UNITED STATES PATENT AND TRADEMARK OFFICE

APPLICATION NO.	FILING DATE	FIRST NAMED INVENTOR	ATTORNEY DOCKET NO.	CONFIRMATION NO.
09/681,403	03/29/2001	Tore Fosse	VCC0082-US	3278

Office Action Summary

FIG. 1

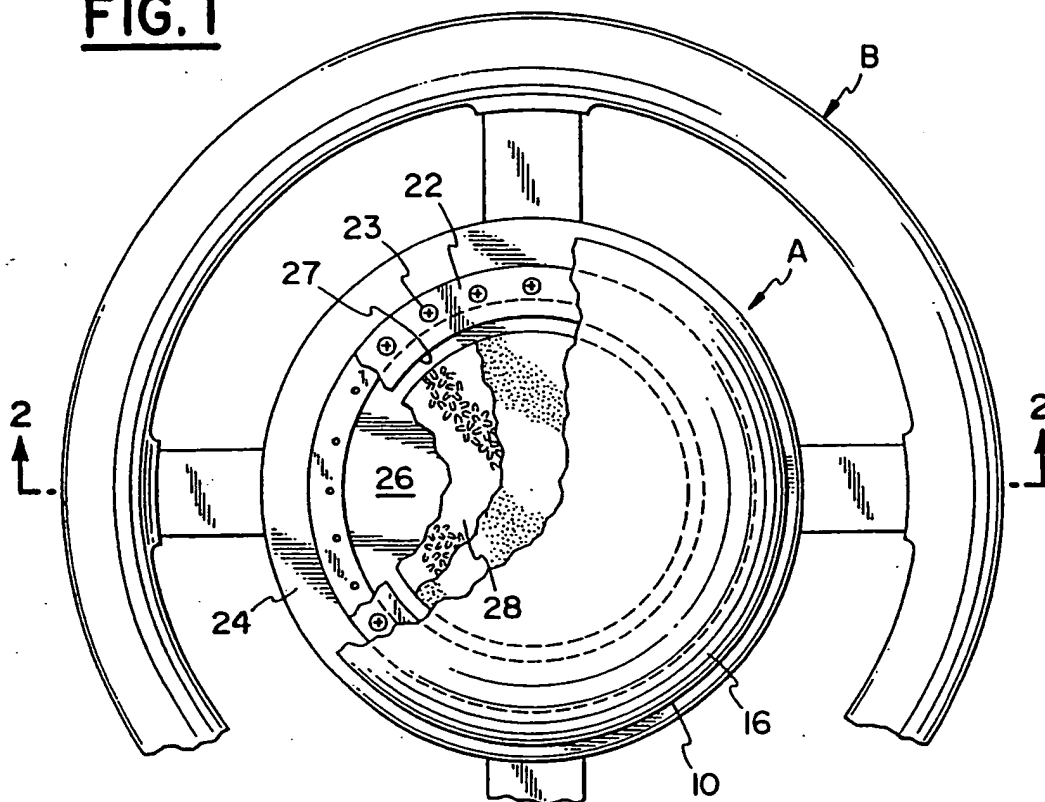
Claims 1 – 26 are rejected under 35 U.S.C. 102(b) as being anticipated by Young (US 5,480,184). Young discloses a hub (see Fig. 2) for fixing to a steering column (S in Fig. 2), a substantially conical bowl-shaped element (see Fig. 2) connected to the hub with at least one

spoke (see Figs. 1, 2), the spoke further connecting the bowl-shaped element to a steering wheel rim (B in Fig. 1, 2), wherein the hub, bowl-shaped element, and at least one spoke are integrally formed as a single material item (see Fig. 2), the bowl-shaped element further comprising an upper shell part (24 in Fig. 2) and lower shell part (see area near 19 in Fig. 2), the upper shell part having larger outer dimensions than the lower shell part and the shell parts being connected by a ledge extending substantially in the radial direction relative to the longitudinal axis of the steering column (see Fig. 2), the bowl-shaped element also comprising a casing for enclosing an airbag and means for inflating the airbag (18 in Fig. 2), where a wall section of the bowl-shaped element at least partly forms part of the means for inflating the airbag (see area, attachment at 19 in Fig. 2).
